KEYSTONE PIPELINE PROJECT - U.S. PHASE IV (STEELE CITY SEGMENT) PIPELINE ROUTE VARIATION FORM			
1	VARIATION TYPE:		
	Refinement: <input type="checkbox"/>	<input checked="" type="checkbox"/>	Reroute: <input type="checkbox"/>
	Centerline: <input checked="" type="checkbox"/>	Valve Site: <input type="checkbox"/>	Pump Station: <input type="checkbox"/>
2	LOCATION:		
	Sketch: <input type="checkbox"/>	<input checked="" type="checkbox"/> Attached	Pictures: <input type="checkbox"/>
	State: <input type="checkbox"/>	<input type="checkbox"/> SD	County: <input type="checkbox"/>
	Township: <input type="checkbox"/>	<input type="checkbox"/> 2N	Range: <input type="checkbox"/>
	Section: <input type="checkbox"/>	<input type="checkbox"/> 1, 6	Centerline: <input type="checkbox"/>
		<input type="checkbox"/> 3/26/2010	MP: <input type="checkbox"/>
		<input type="checkbox"/>	to <input type="checkbox"/>
		<input type="checkbox"/>	<input type="checkbox"/> 464.81 <input type="checkbox"/> to <input type="checkbox"/> 465.37

KEYSTONE PIPELINE PROJECT - U.S. PHASE IV (STEELE CITY SEGMENT) ROUTE VARIATION AUTHORIZATION FORM	
Date: <input type="text" value="10/6/2010"/> Description: <input type="text" value="Rerou

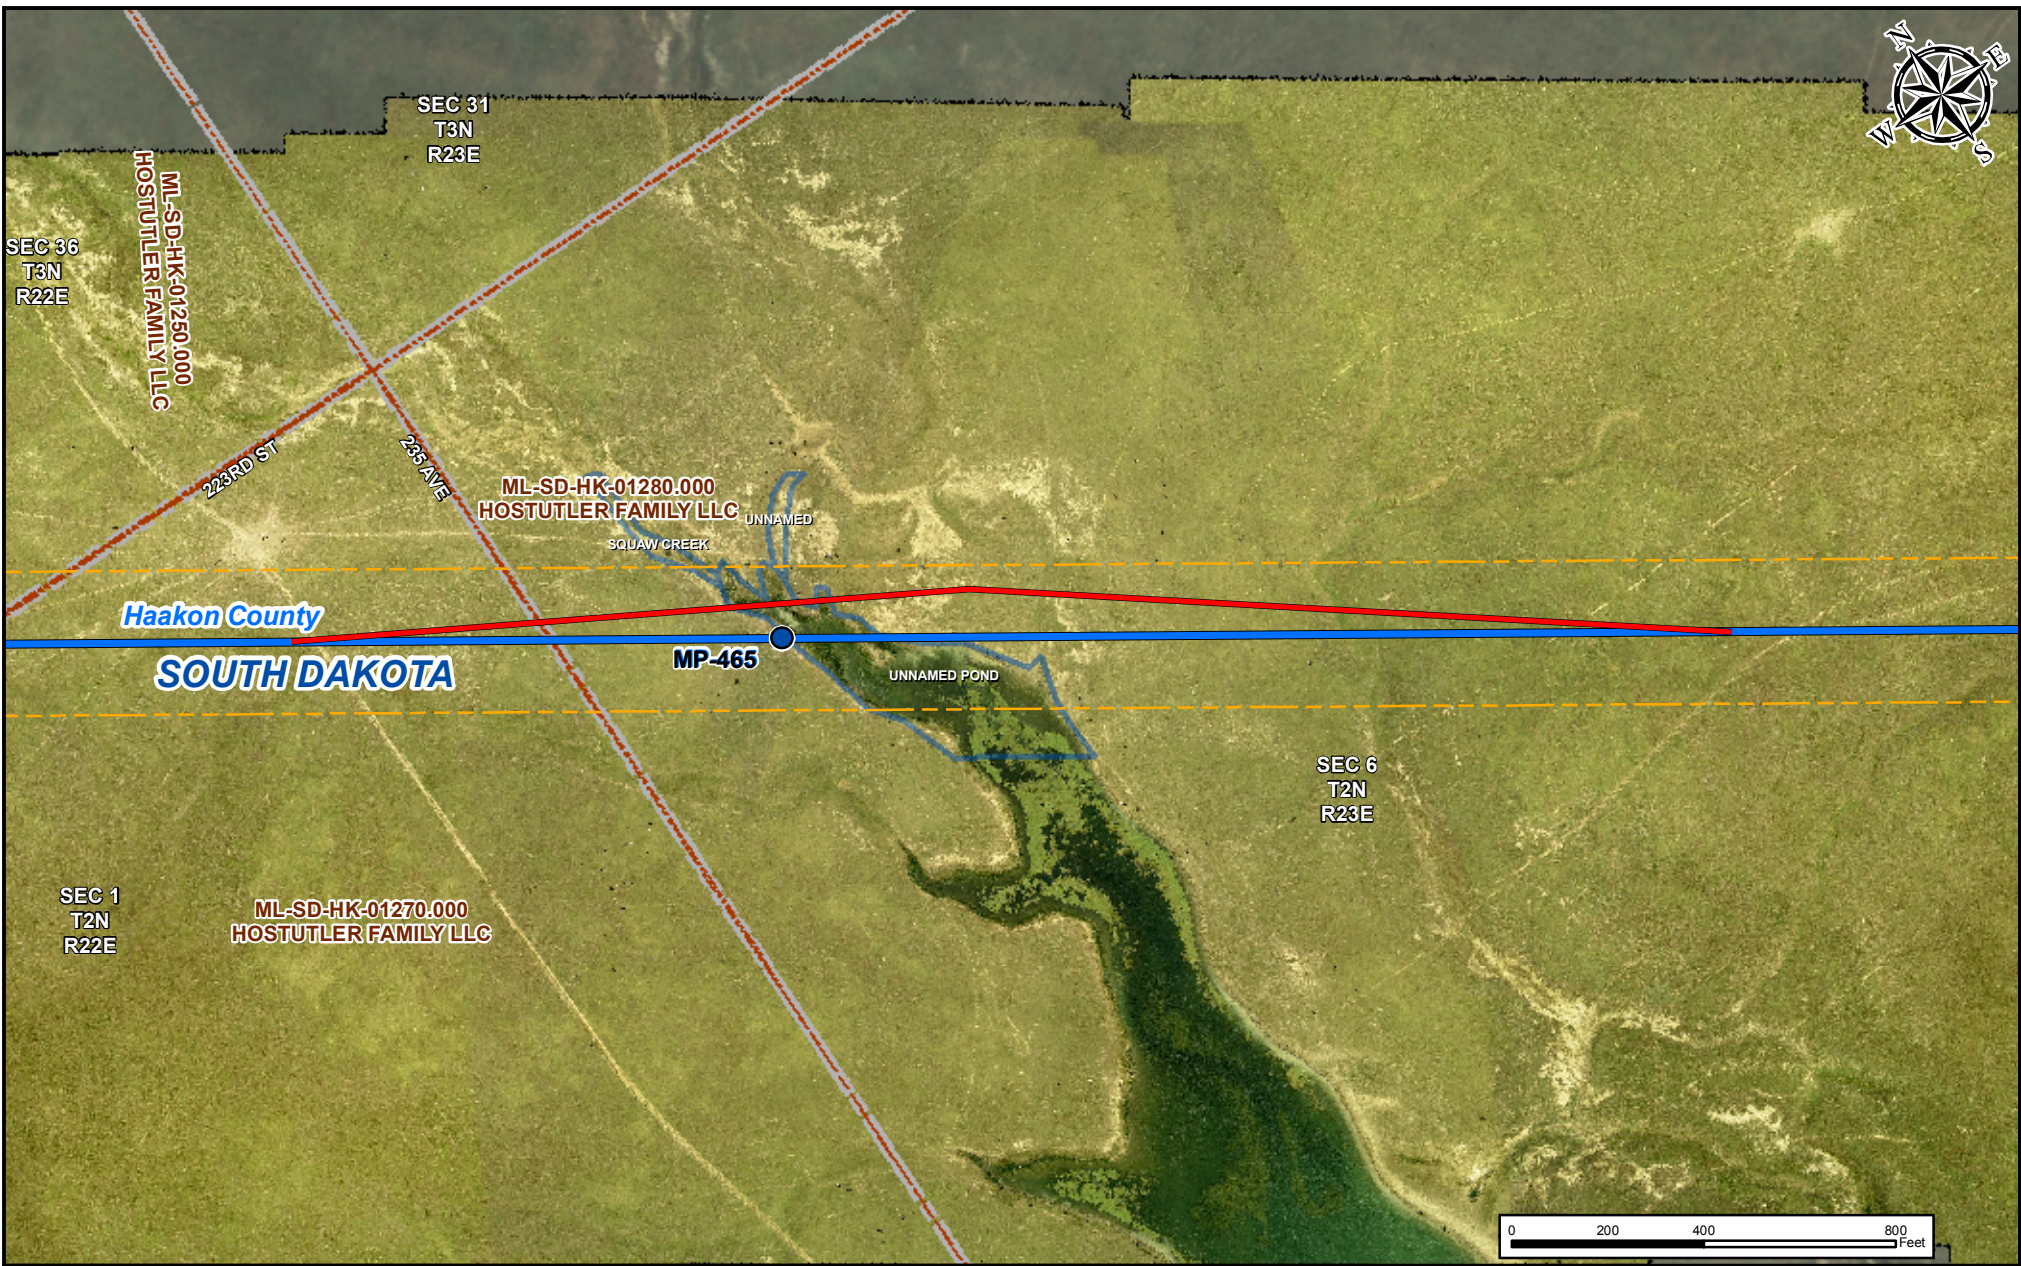
3	REASON FOR ROUTE VARIATION (Please include reason for route variation):		
<p>The centerline currently passes through a pond at MP 465. This reroute is proposed to accommodate landowner's (Hostutler Family LLC) request to locate the centerline at a less severe crossing of the waterbody, as specified by the landowner. The proposed reroute has been civil surveyed based on Landowner's recommendation.</p>			
DETAIL ROUTE VARIATION (Please describe route variation in detail):			
<p>The proposed reroute starts at MP 464.8 and deviates slightly (~4°) from the centerline towards the southeast. It continues in this direction for ~1,420 ft. Along its path it crosses the waterbody at the location specified by the landowner, ~75 ft northeast of its current crossing location. The proposed reroute then turns towards the south and continues 1,590 ft to rejoin the centerline at ~MP 465.4.</p> <p>The proposed reroute has been civil surveyed.</p>

Added (+): 1 pond and 2 ephemeral streams Subtracted (-): 1 pond

Trow - Environmental Jonathan Minton Comments: <input type="text" value="The route variation still does not avoid the pond as delineated in the field."/>	Variation: Approved <input checked="" type="checkbox"/> Rejected <input type="checkbox"/> <i>Jonathan Minton</i> <input type="text"/> Date: <input type="text" value="10/8/2010"/> If Rejected Why? <input type="text"/>
AECOM - Risk Assessment Heidi Tillquist Comments: <input type="text" value="This reroute does not significantly alter risk to HCAs and, therefore is acceptable from a risk perspective."/>	Variation: Approved <input checked="" type="checkbox"/> Rejected <input type="checkbox"/> <i>Heidi Tillquist</i> <input type="text"/> Date: <input type="text" value="10/19/2010"/> If Rejected Why? <input type="text"/>
Project Management Butch Wallace Comments: <input type="text"/>	Variation: Approved <input checked="" type="checkbox"/> Rejected <input type="checkbox"/> <i>R.E. Wallace</i> <input type="text"/> Date: <input type="text" value="10/6/2010"/> If Rejected Why? <input type="text"/>
